BOARD ACTION REPORT – APPEALABLE ITEM

Project Name: 235 NE 1st Avenue
Project Location: 235 NE 1st Avenue, Old School Square Historic District
Request: Certificate of Appropriateness (2019-250) and Variance (2019-251)
Board: Historic Preservation Board
Meeting Date: October 2, 2019

HISTORIC PRESERVATION BOARD STAFF REPORT

Meeting	File No.	Application Type
October 2, 2019	2019-250 & 251	Certificate of Appropriateness and Variance

Typical Window with Shutters Detail

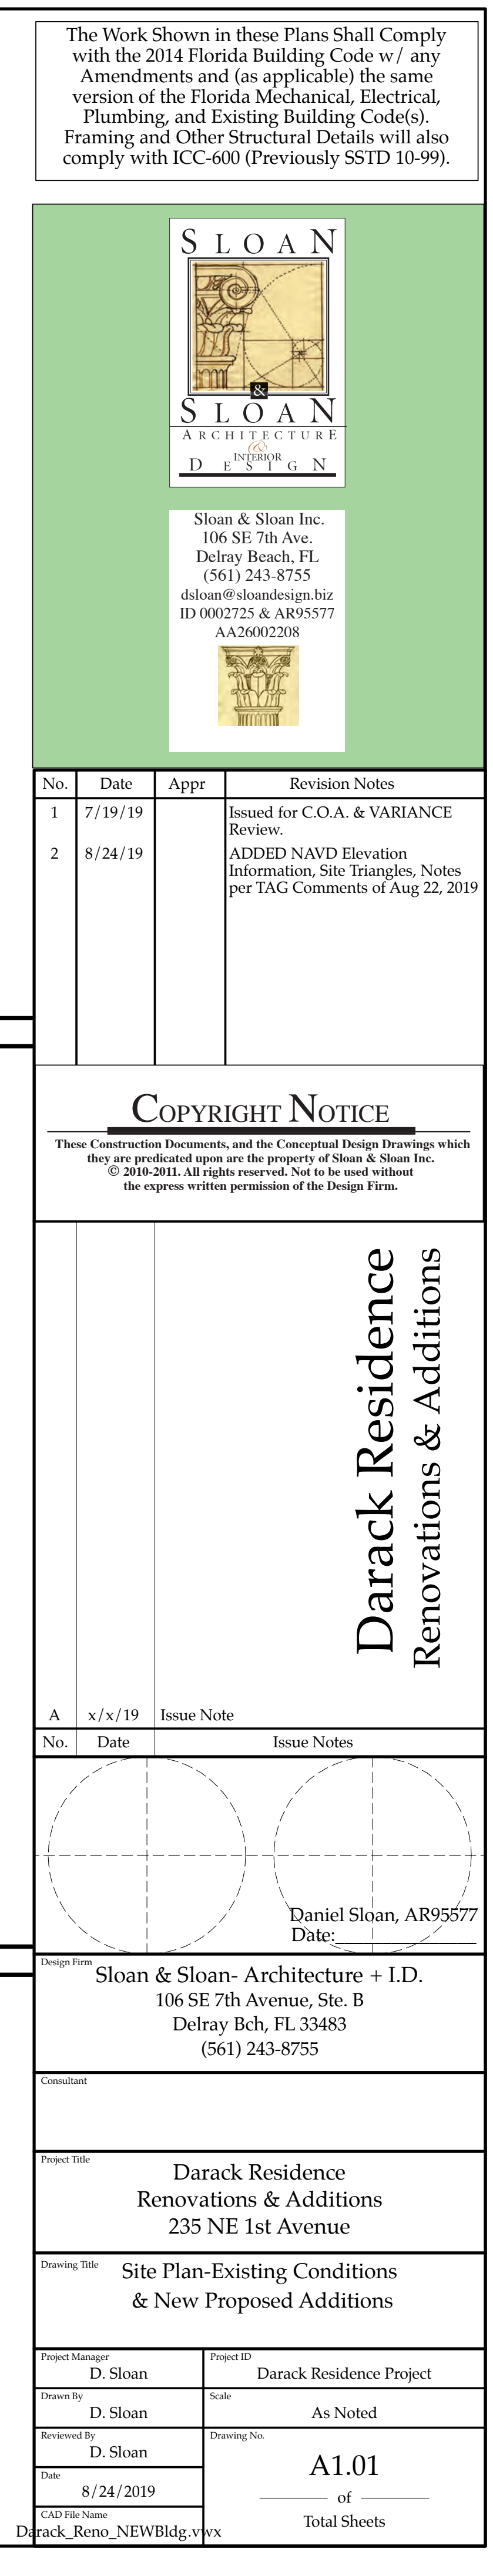
With regard to decorative shutters, photographs of the existing contributing structure depict windows on the front porch not having wooden shutters. It appears that there isn't enough space on the façade to accommodate operable shutters, which may be why the original awning was used to serve the purpose of providing shade and shelter from the elements.

If shutters on the front windows are proposed, a condition would be to make them appear as a double foldout to give the appearance of each side matching half the width of the window. The addition of shutter dogs would also give a more operable appearance.

1. That the elevation plans be updated to illustrate the existing fabric awning on the façade; and,
2. That any proposed shutters to the front windows be created to appear operable, and that shutter dogs be used.

Drawing Title: NEW N-S-E-W ELEVATIONS of Main Residence

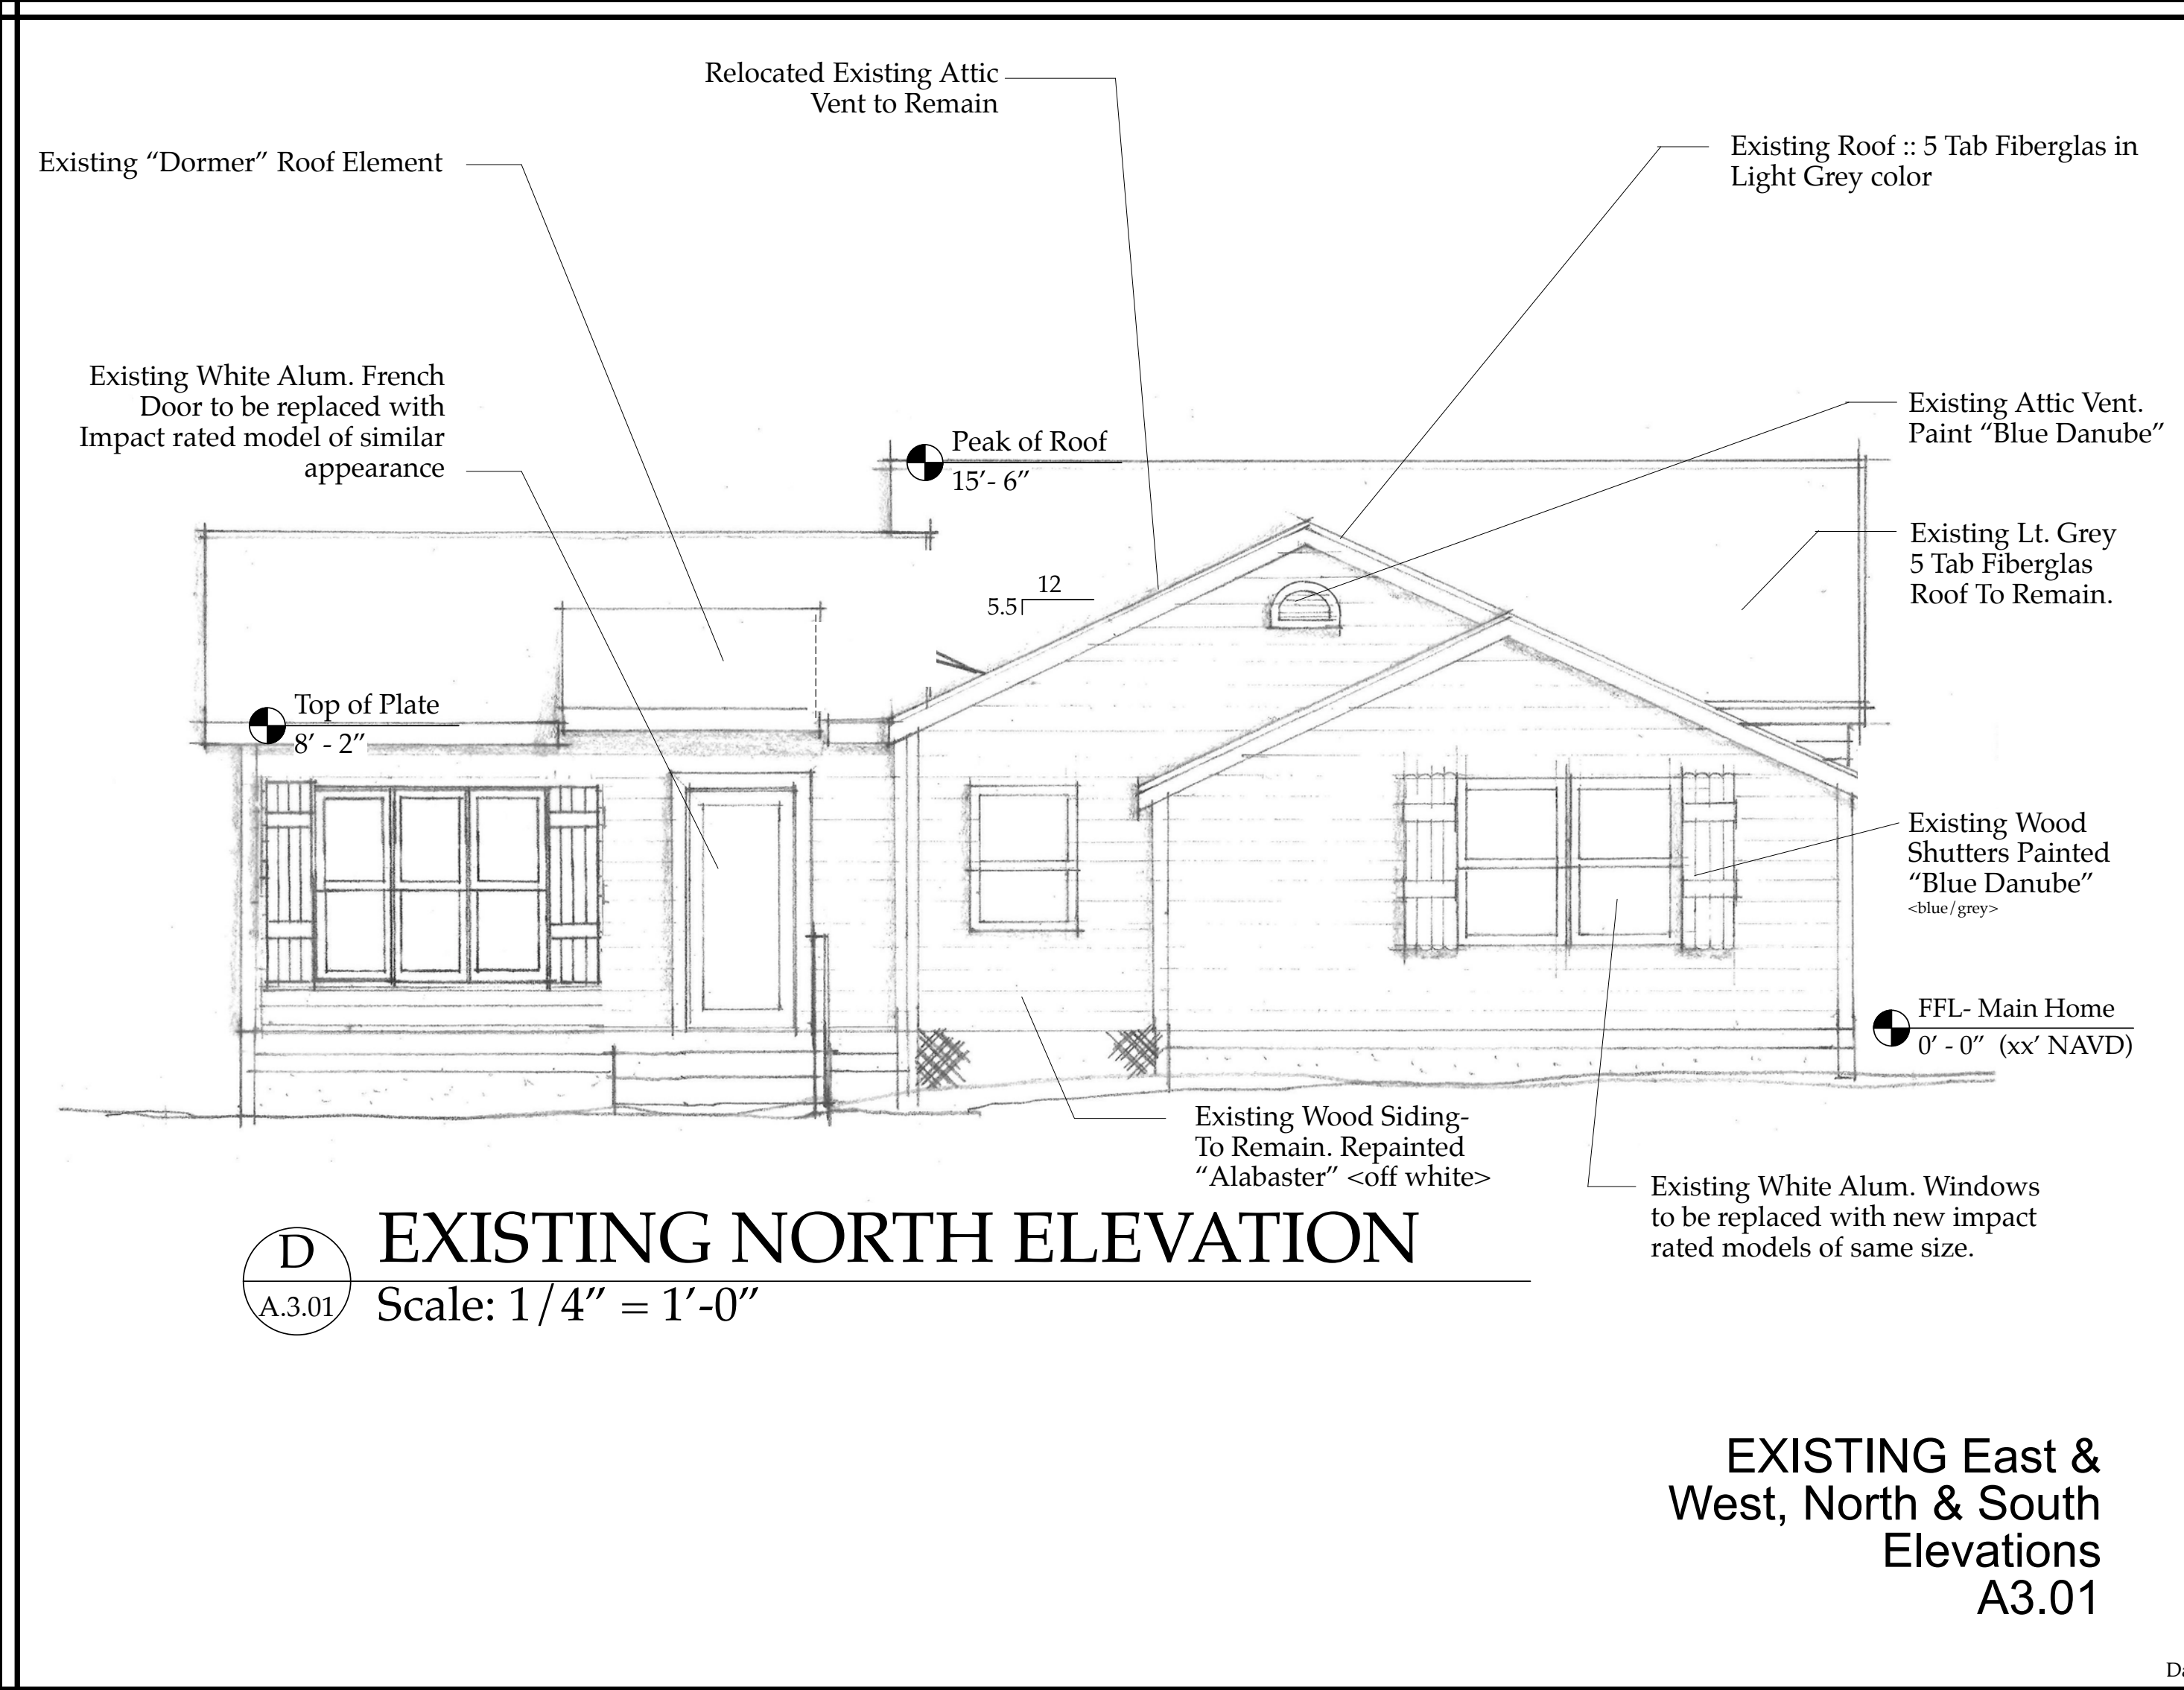
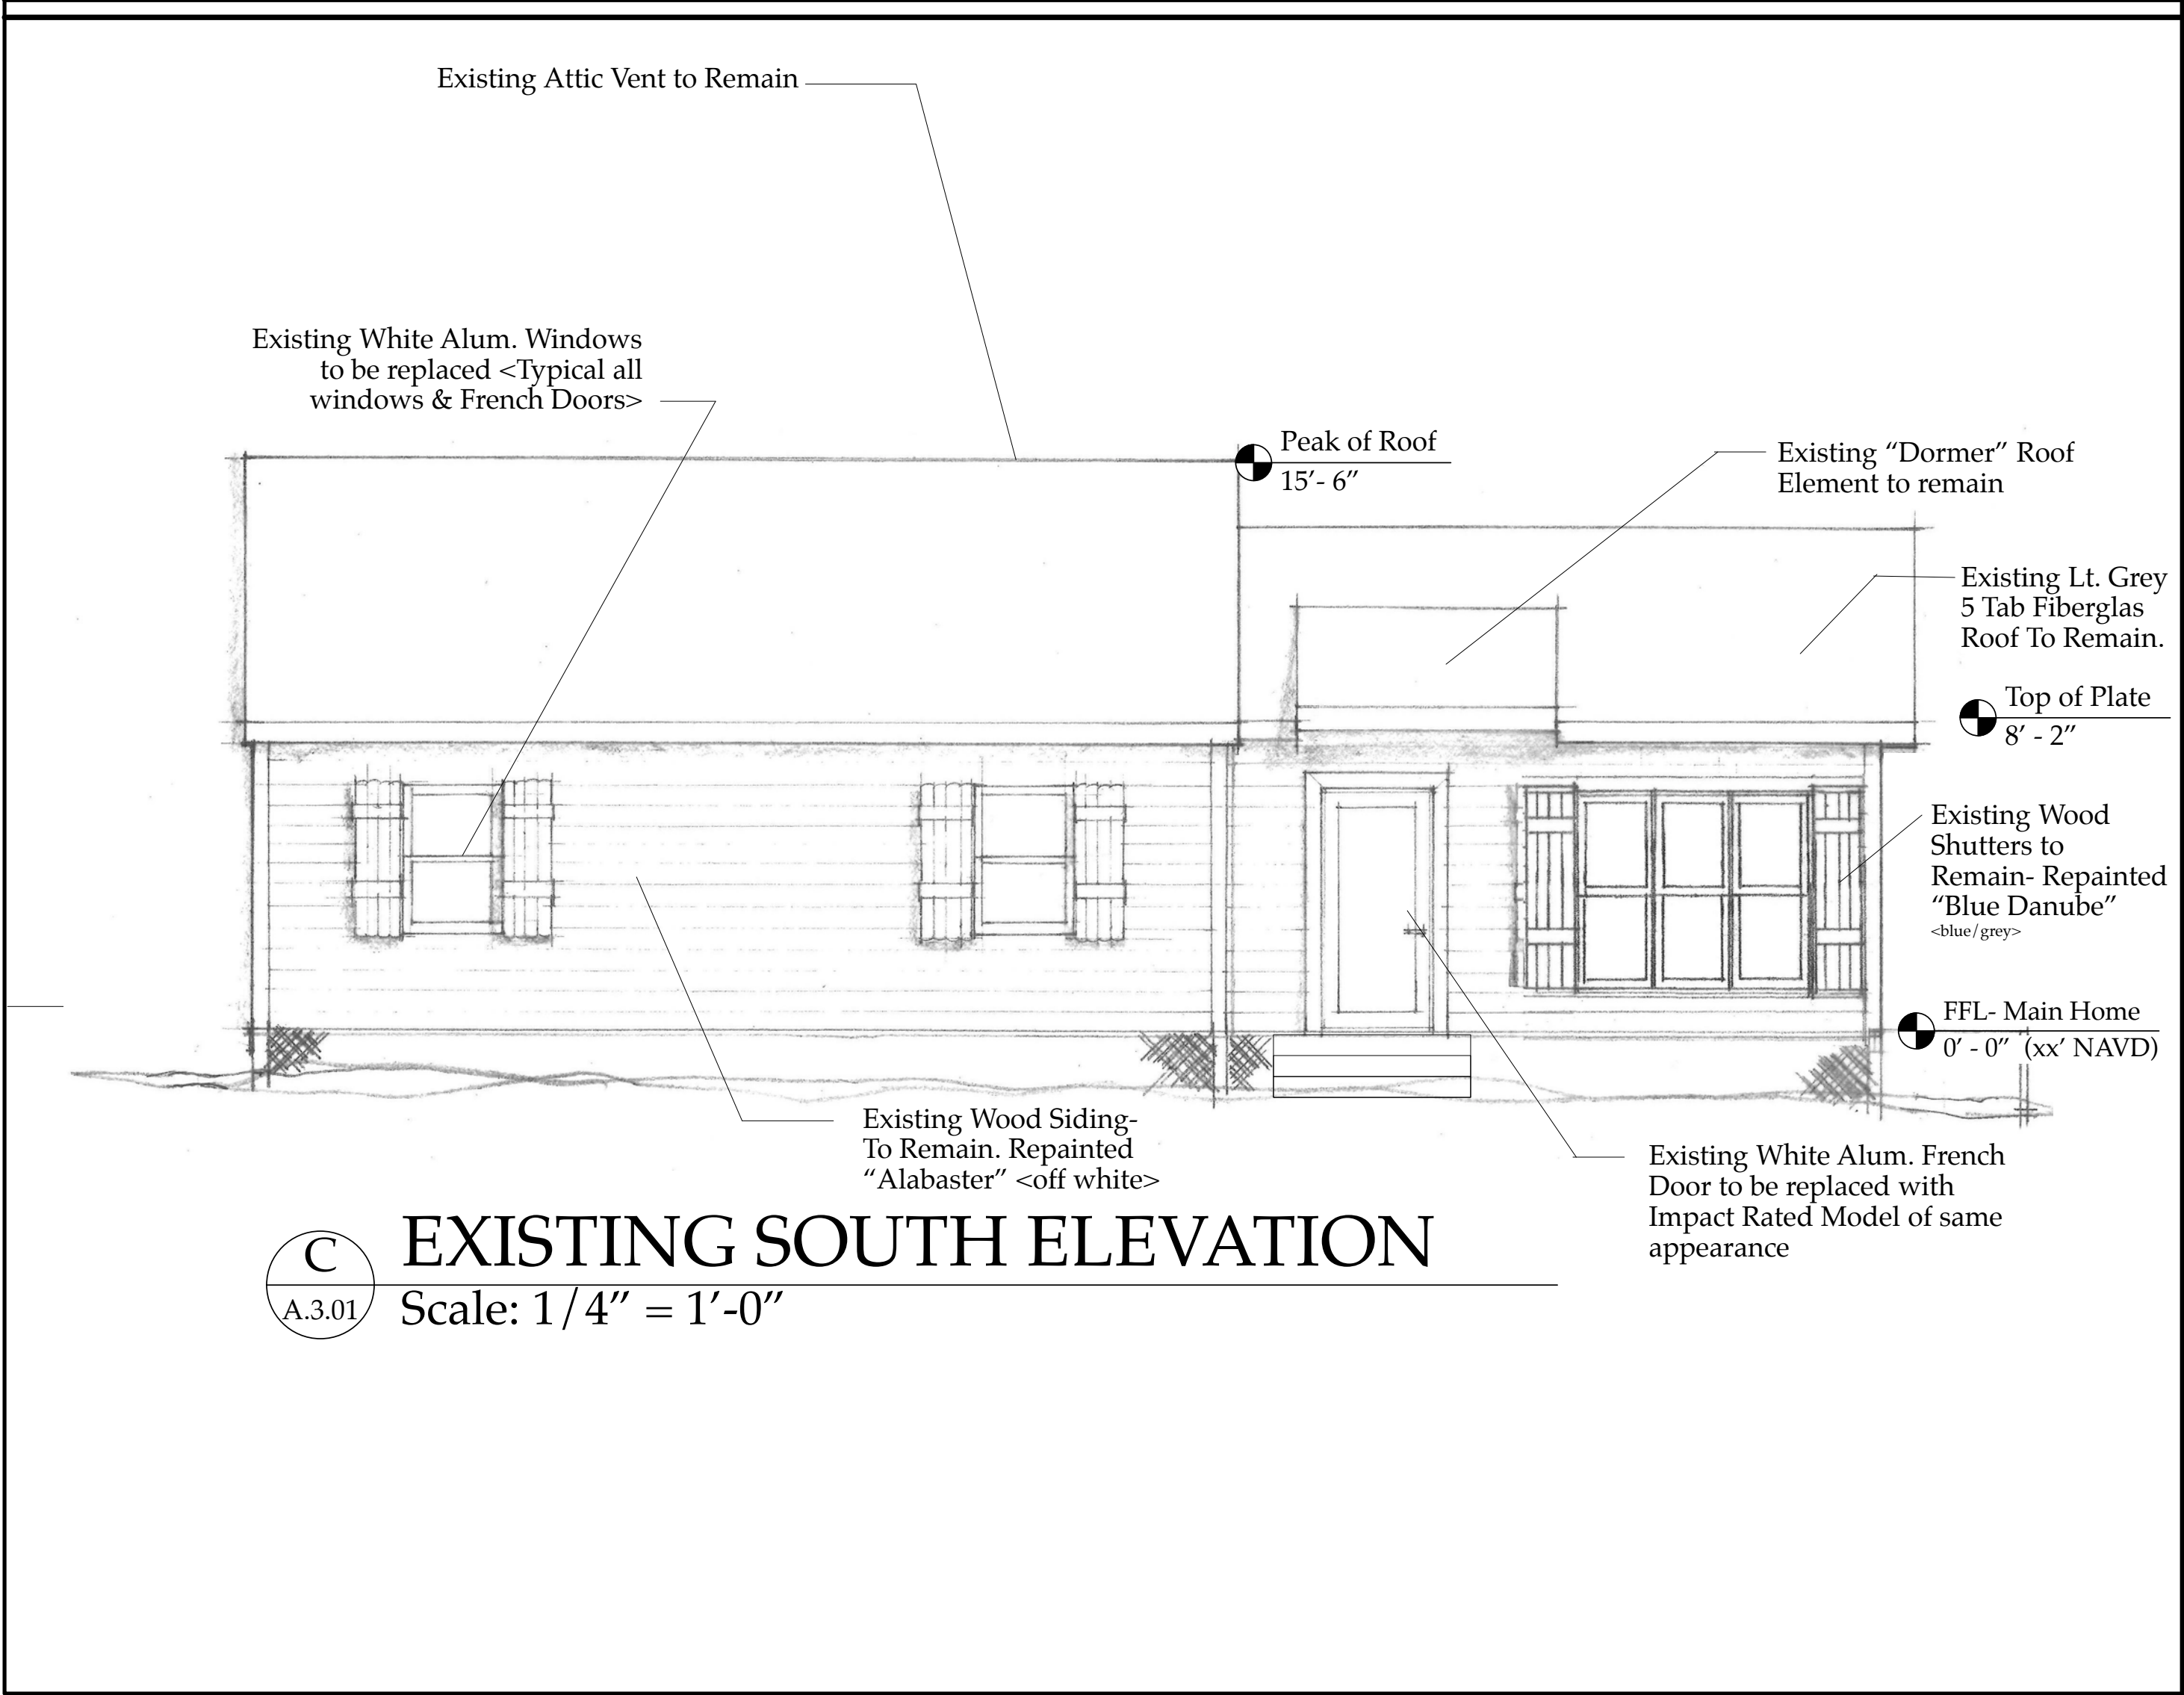
Standard 1, 2, 3, 5, 9, & 10 are applicable. The proposal includes replacement of the existing, projecting, fabric awning from the front façade with a wood framed, projecting and sloped, 3-dimensional asphalt shingle roof. It is noted that the elevation plans do not illustrate the existing fabric awning and must be updated to illustrate this existing condition. This item is added as a condition of approval.

The proposal includes replacement of the existing, projecting, fabric awning from the front façade with a more permanent projecting/sloped, shingle asphalt roof element. The new roof feature will have a wood frame. It is noted that the elevation plans do not illustrate the existing fabric awning and must be updated to illustrate this existing condition. This item is added as a condition of approval. The new porch roof shingles will be "Cool Slate", which is a light grey and will match the color of the existing shingle roof. As a contributing structure within an historic district, it is imperative that the architectural style and its original features be preserved accurately. The proposed slope roof does not introduce a new feature to structure as a projecting fabric awning exists in this location; therefore, it can be considered an appropriate alteration.
